PL202100017

PHASE III - CONCEPT 3

U-HAUL  
BLOOMINGTON, MINNESOTA - 01/27/2021  
ISG PROJECT NO. 20-24791

**U-HAUL  
PHASE III  
WAREHOUSE**

**A2-12**

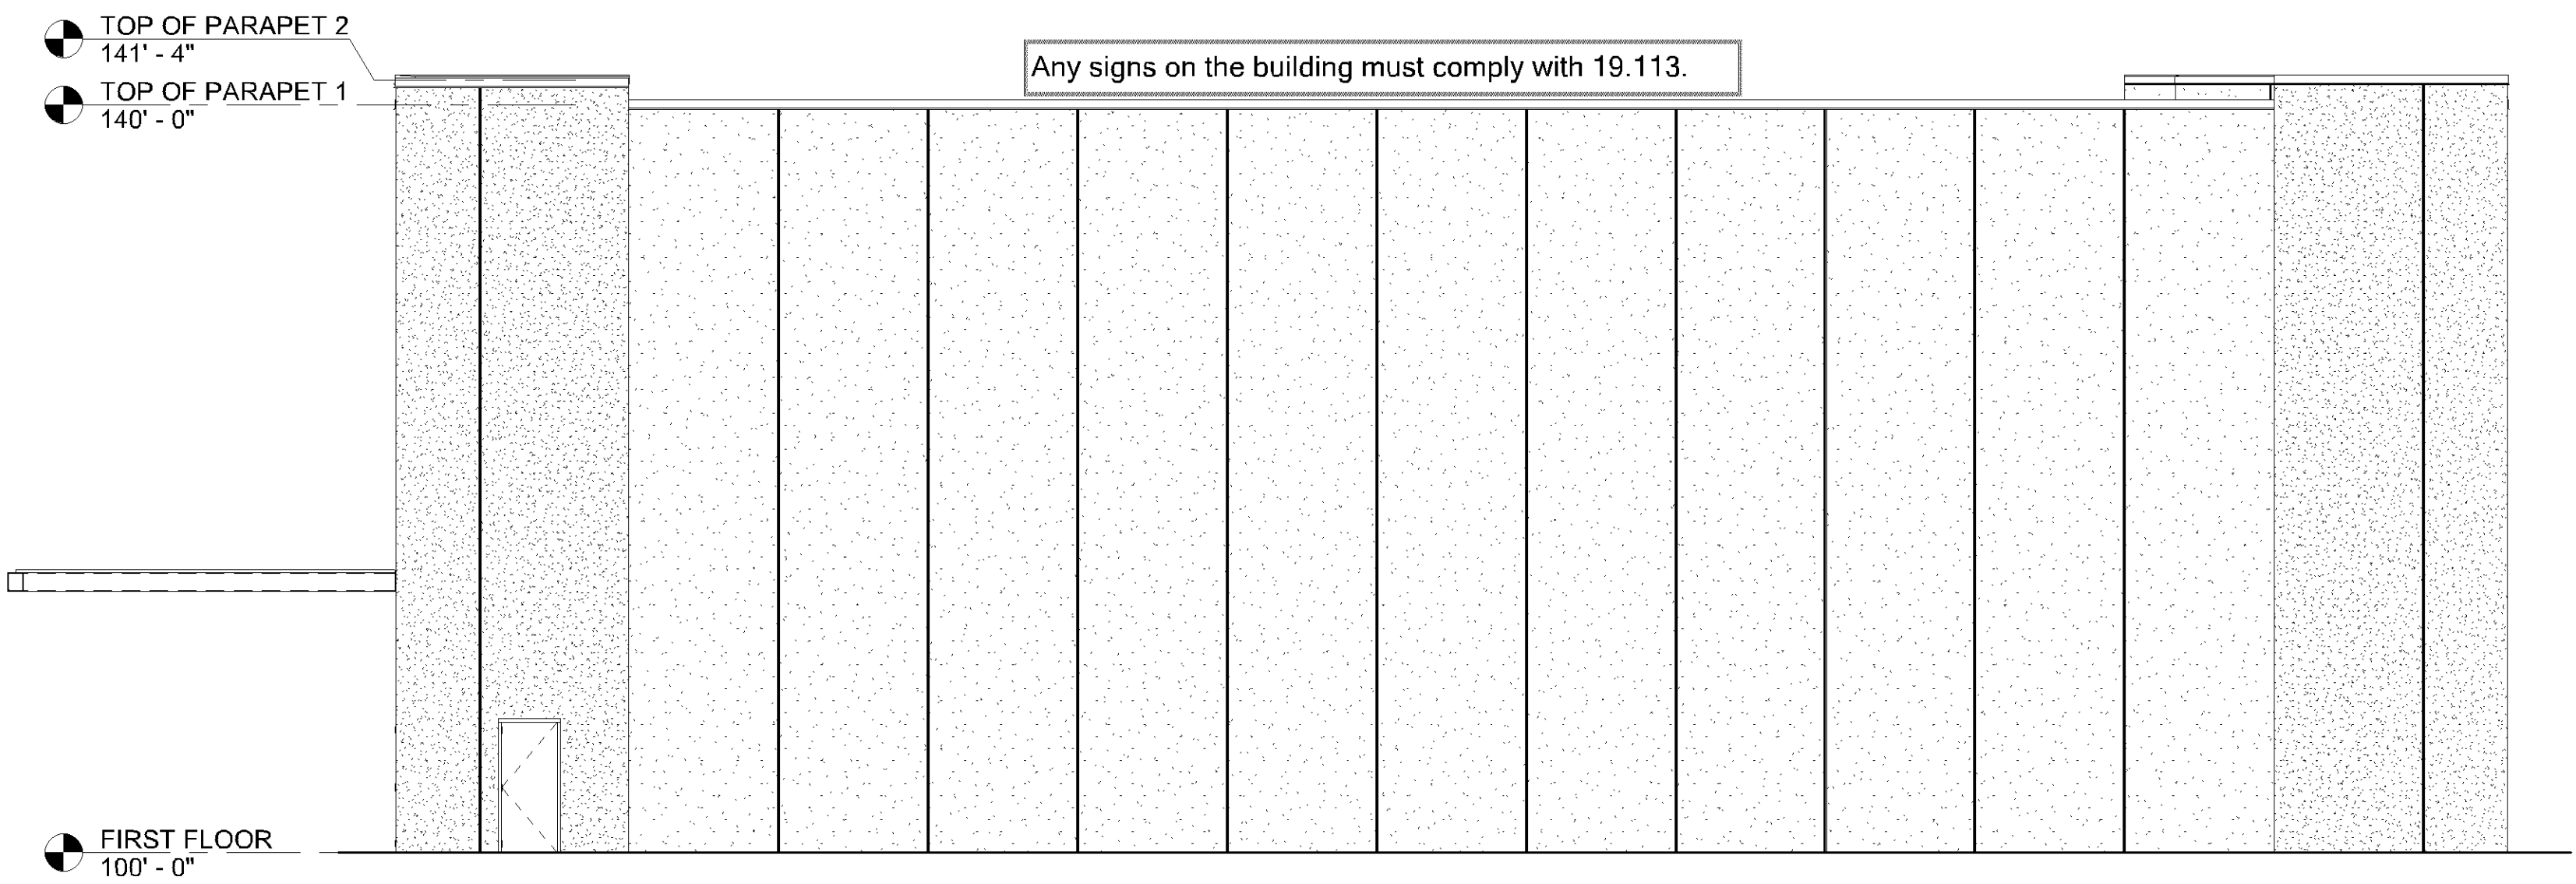
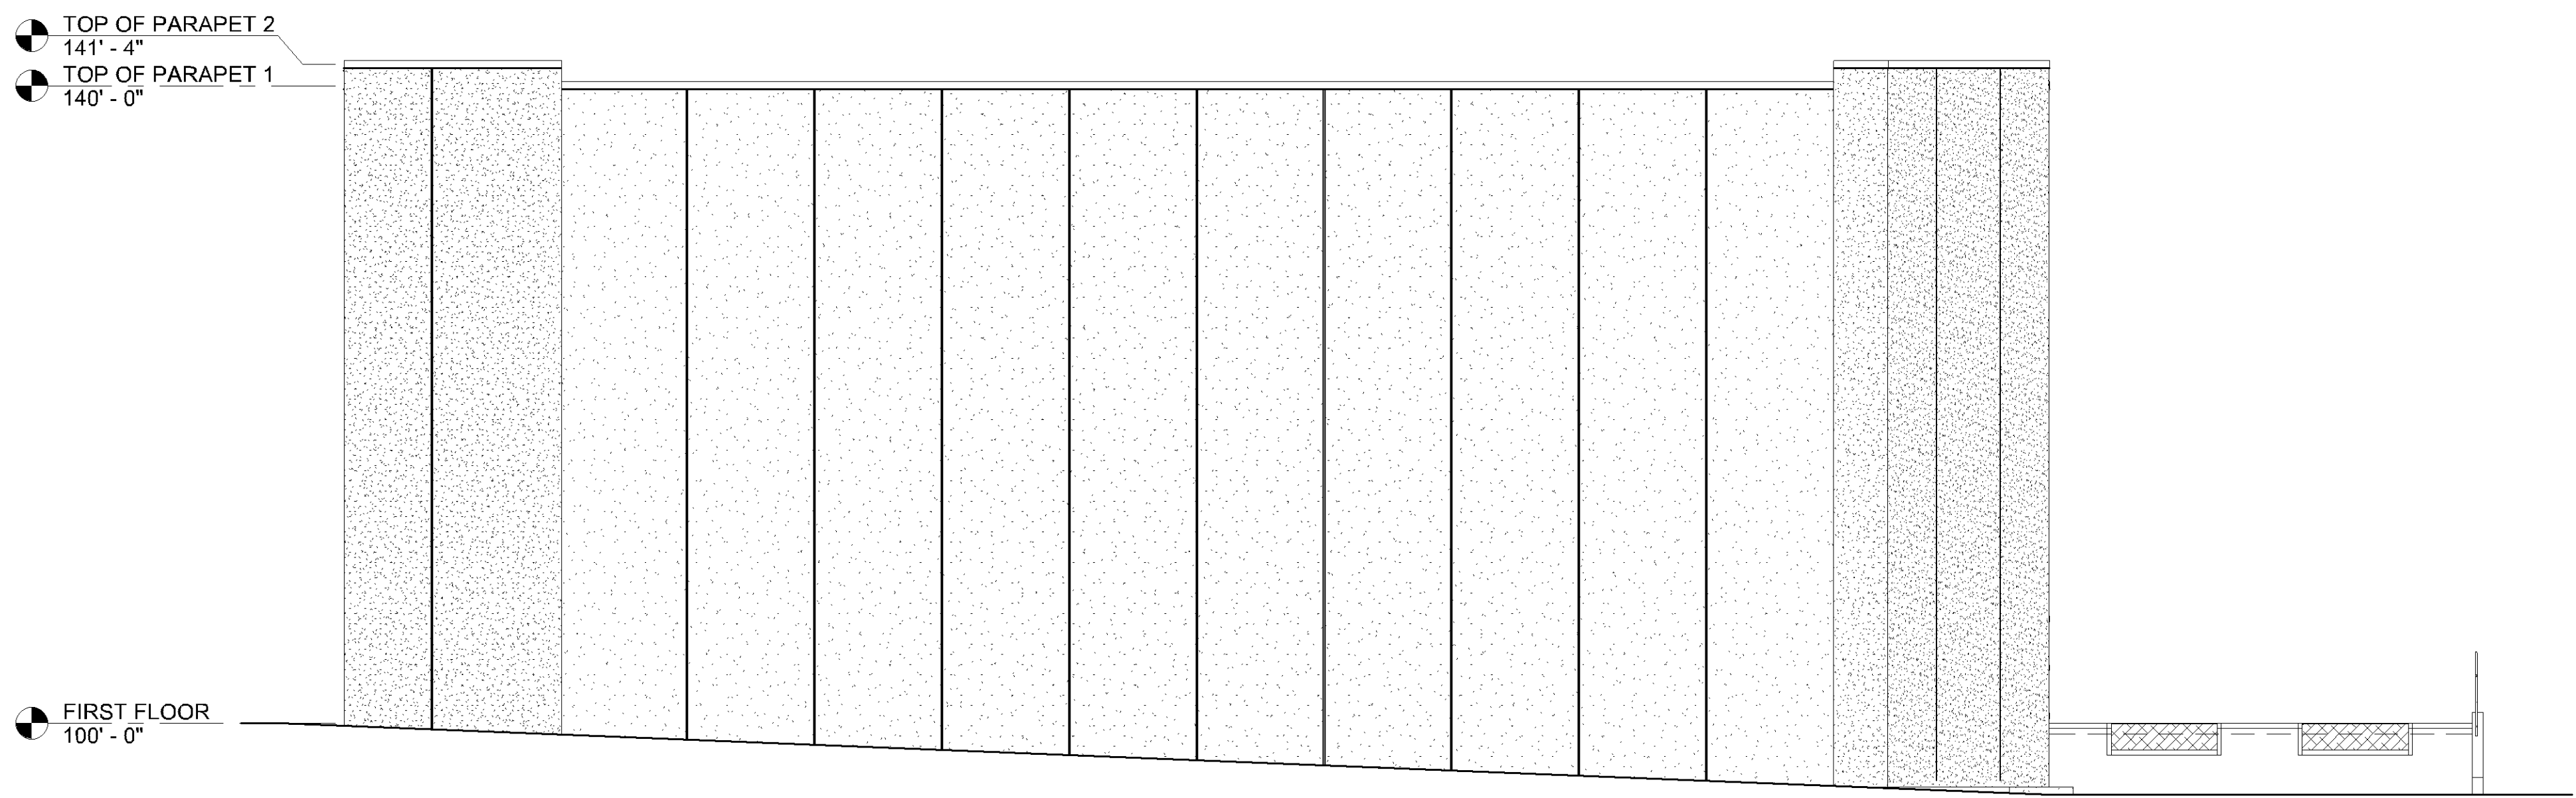
Any signs on the building must comply with 19.113.
